SUNDRY NOTICES AND REPORTS ON WELLS

| | II. Use form 3160-3 (APD) for | | | o. Il maian, motice c | THOC Name |
|---|---|--|---|-------------------------------|------------------------|
| ☐ Oil Well 	☐ Gas Well ☐ Other . | | | | GALLEGOS CANYON UNIT 265 | |

Gallegos Canyon Unit 265

BP would like to request approval to amend the P&A program for GCU 265 as per following procedure.

- current wellbore diagram
- proposed WBD P&A

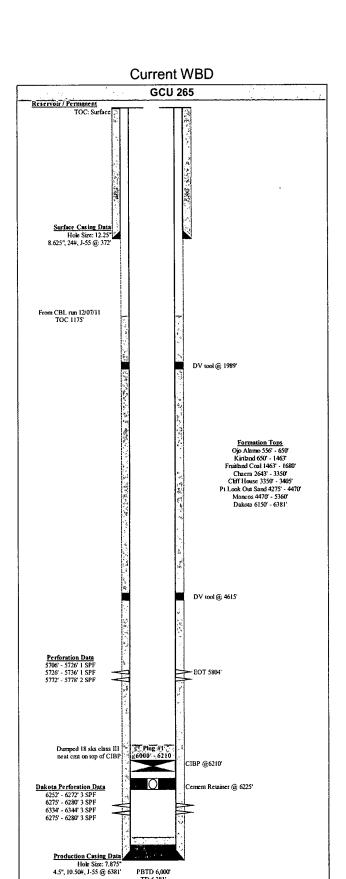
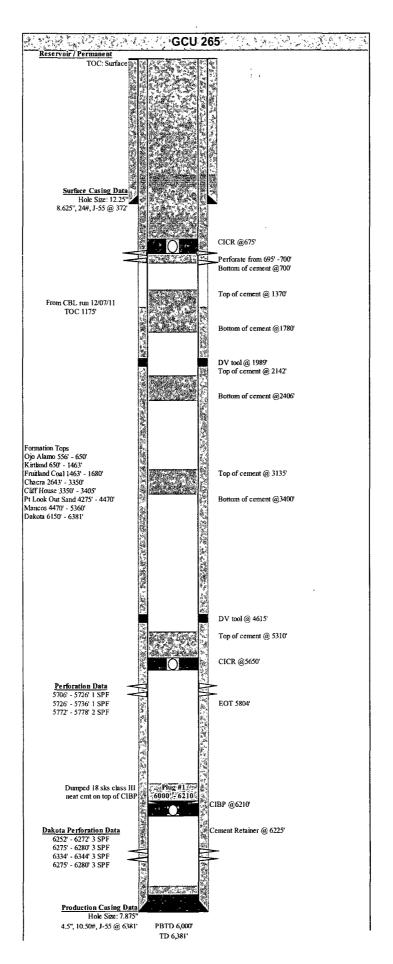
All cement will be class B, mixed at 15.60 ppg, 1.18 cf/sx

- 1. RIH and set a cement retainer @ 5650'. MIT (500psi)
- 2. Pump balanced cement plug on top of CICR 5.4 bbls/26sks (Top Mancos perforations)
- 3. POH to 3400' and pump 4.2 bbls/20sks cement plug (Mesaverde top)

- 4. POH to 2406' and pump 4.2 bbls/20sks cement plug (Chacra top)
- 5. POH to 1780' and pump 6.5 bbls/31sks cement plug (Picture Cliffs and Fruitland tops)

- 6. POOH and LD tubing
- 7. RIH and perforate 5' from 700'-695'
- 8. Try to establish circulation to surface.
- 9. If GOOD circulation to surface, then Set cement retainer at 675'

- 10. Balance plug 11.0 bbls inside and 31 bbls outside casing. Mix 200 sks. Continue step 17
- 11. If **NO** circulation to surface, then pump 3.3 bbls inside casing from 700'.16sks cement plug (Kirtland and Ojo Alamo tops)

- 12. RIH and perforate 5' from 435'-430'
- 13. Establish circulation to surface
- 14. Set cement retainer at 410'
- 15. Balance plug 7.0 bbls inside and 19.0 bbls outside casing. Mix 130 sks.

- 16. Cut wellhead and weld plate with marker and P&A information
